Monastery Cove Phase 2

CONSTRUCTION DOCUMENTS Weber County, Utah

PLAN AND PROFILE
MONASTERY COVE PHASE 2
2075 SOUTH (ARTIST WAY)
HUNTSVILLE CITY, WEBER COUNTY, UTAH

CE2-02

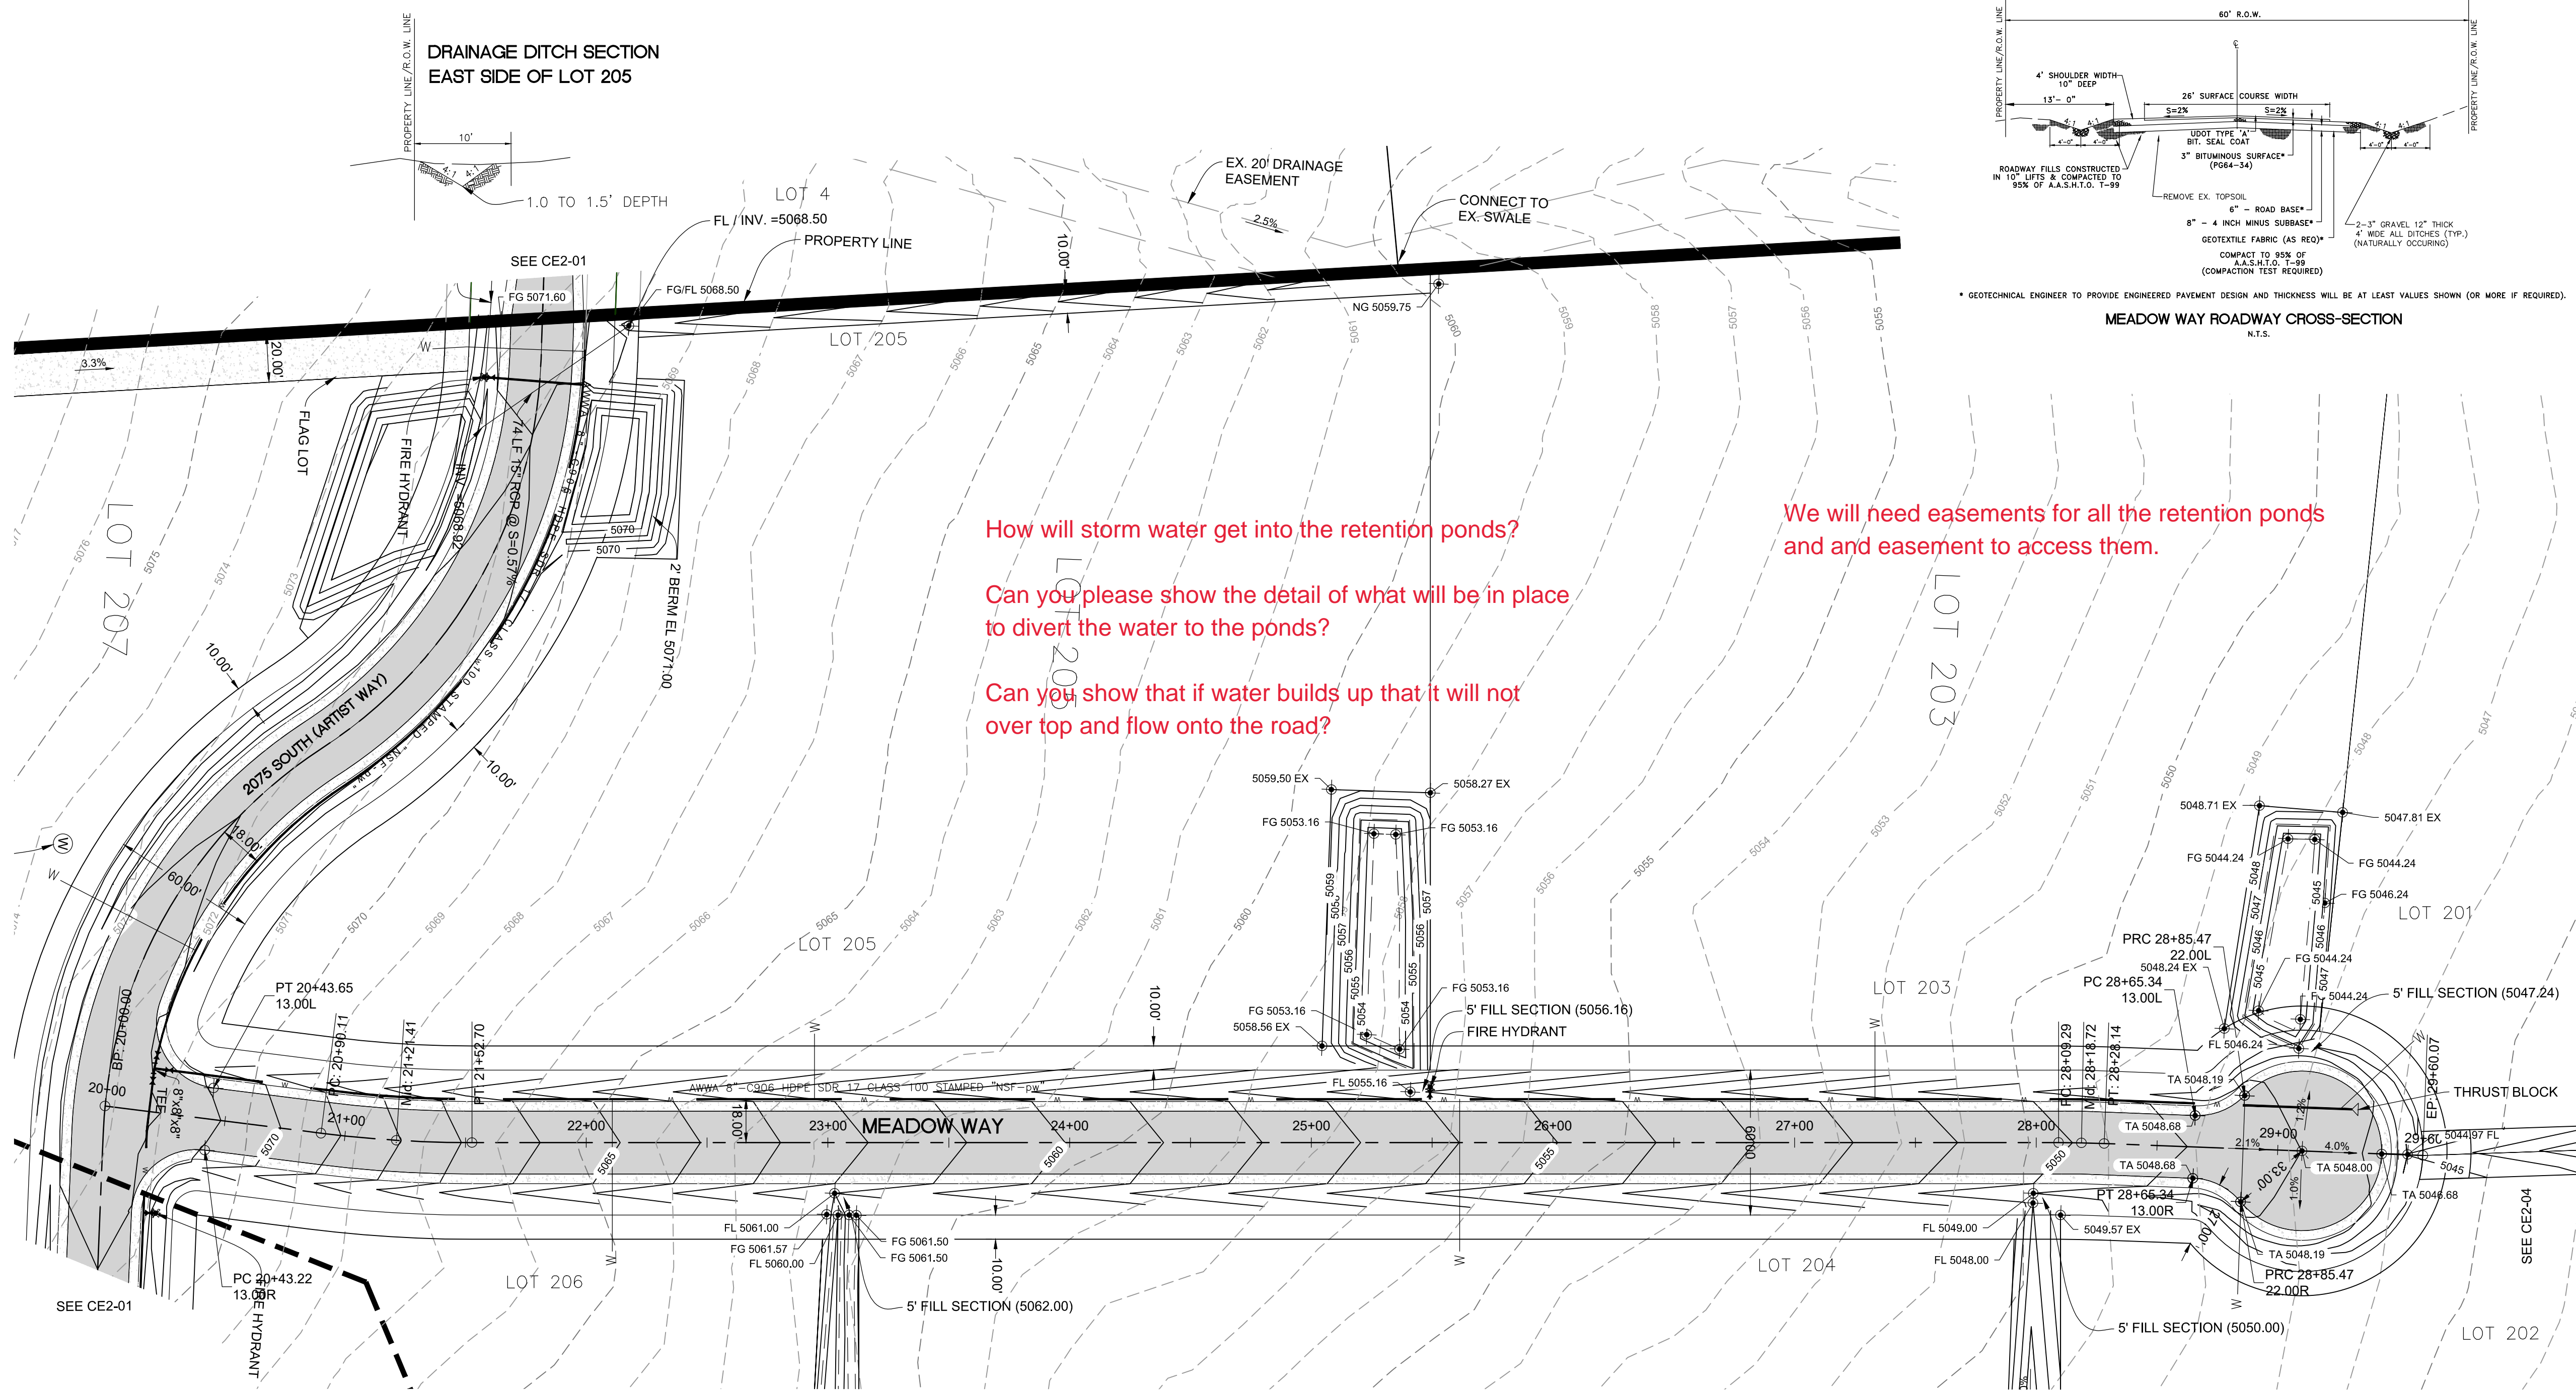
How will storm water get into the retention ponds?

Can you please show the detail of what will be in place to divert the water to the ponds?

Can you show that if water builds up that it will not over top and flow onto the road?

We will need easements for all the retention ponds and an easement to access them.

CE2-04

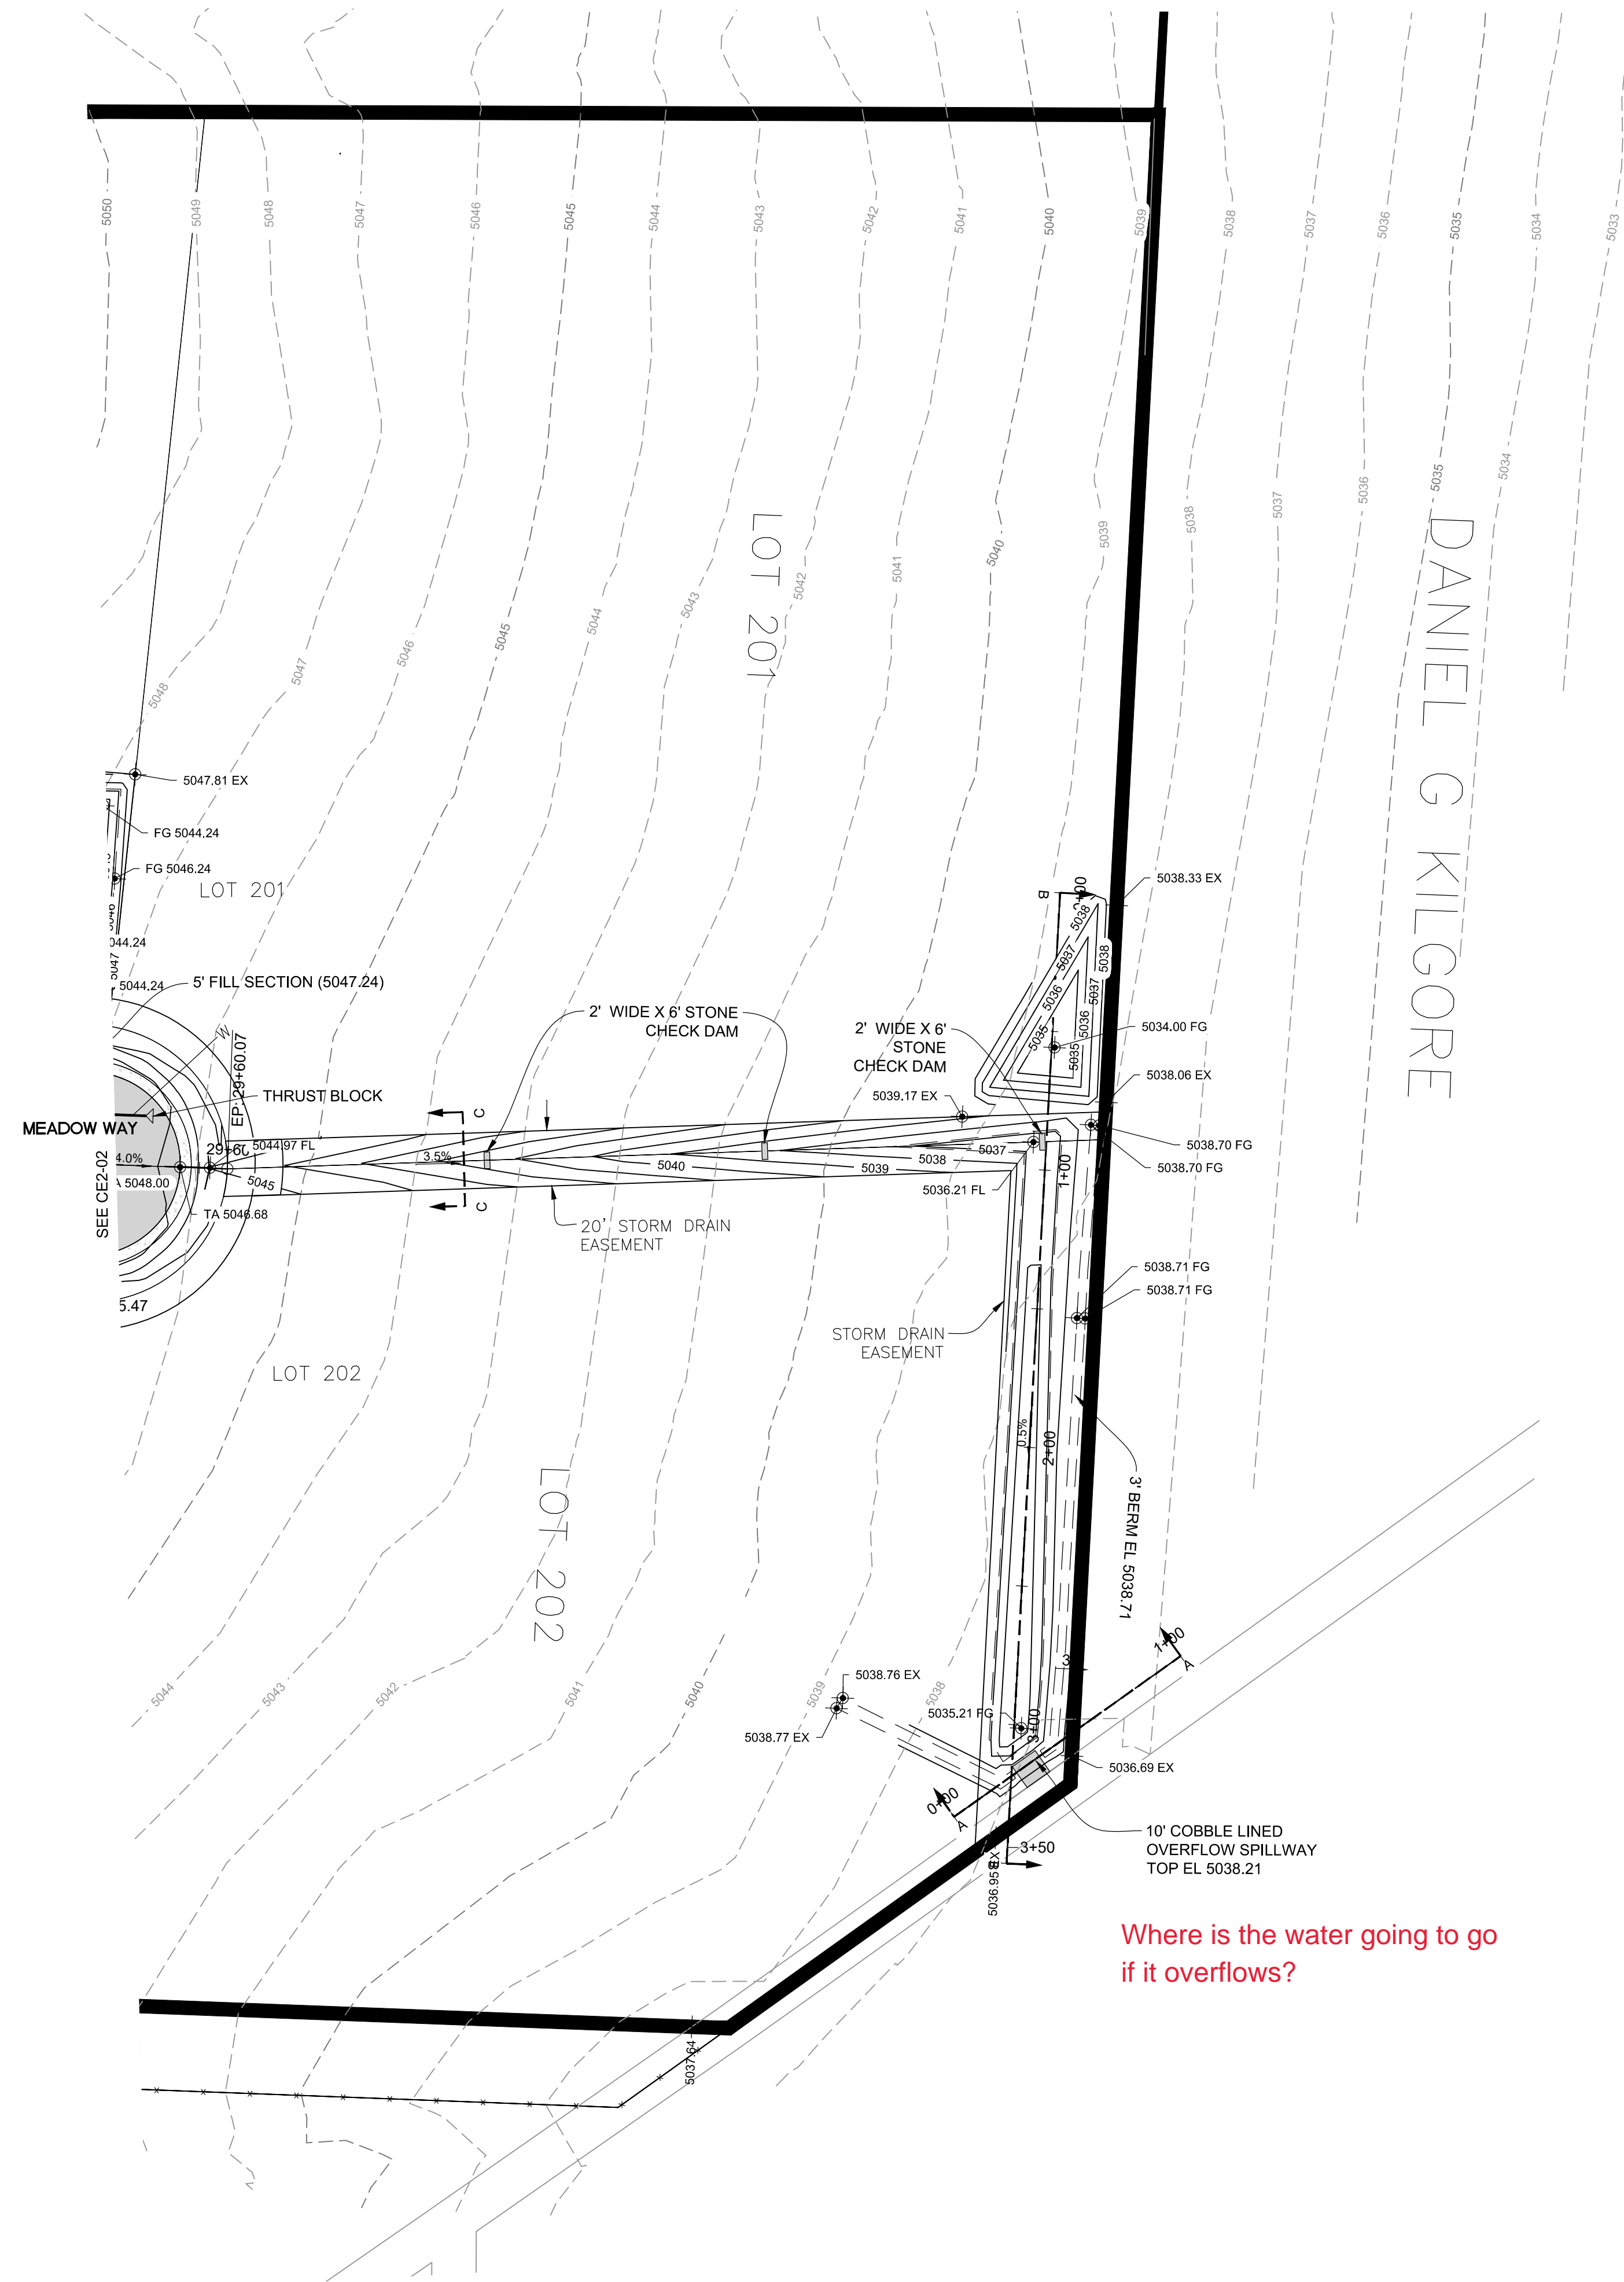
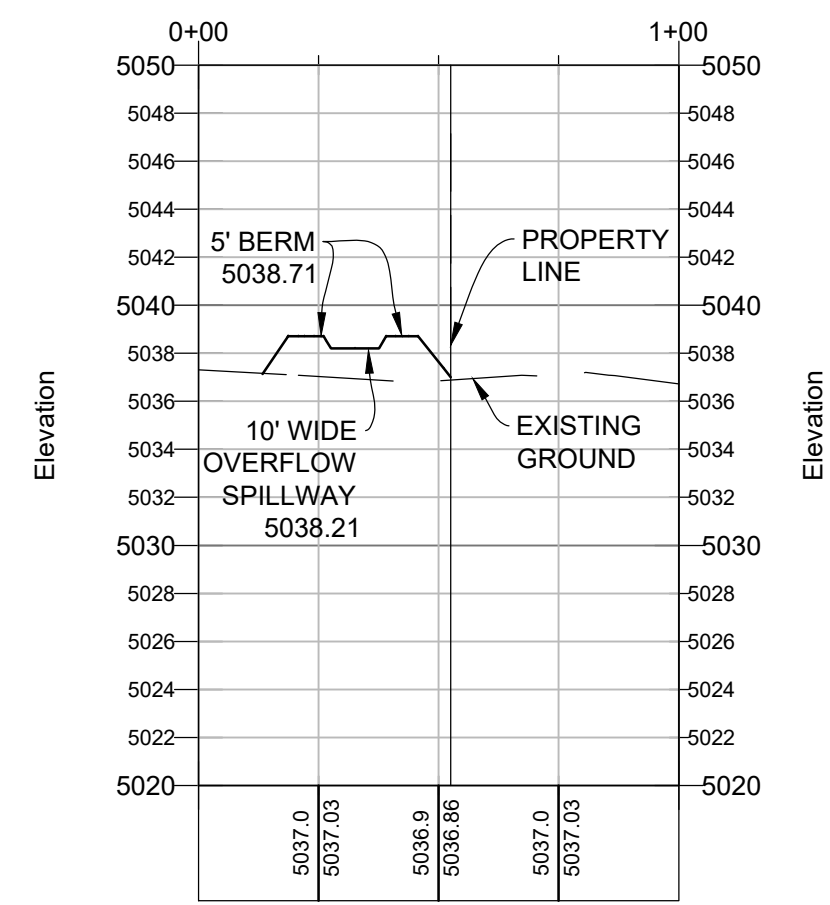
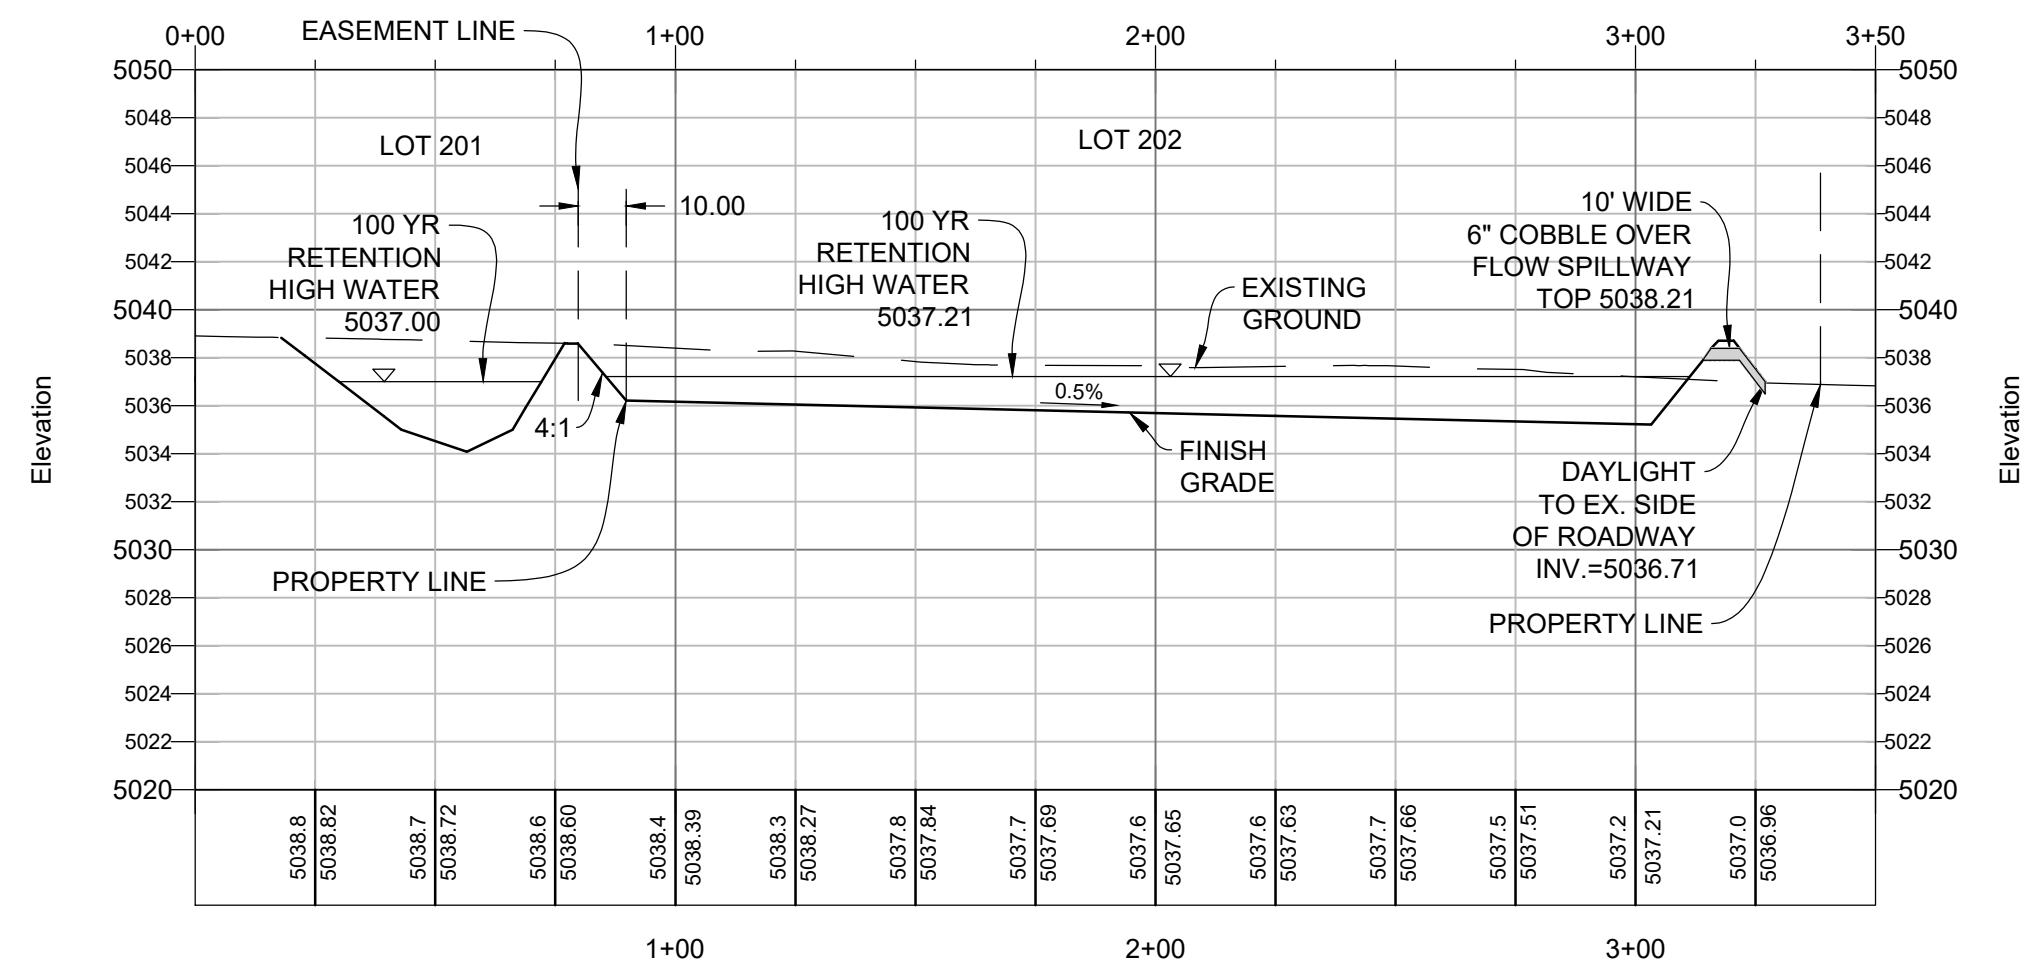
Can you provide more information on the berm and show its elevation on the profile.

Where is the water going to go if it overflows?
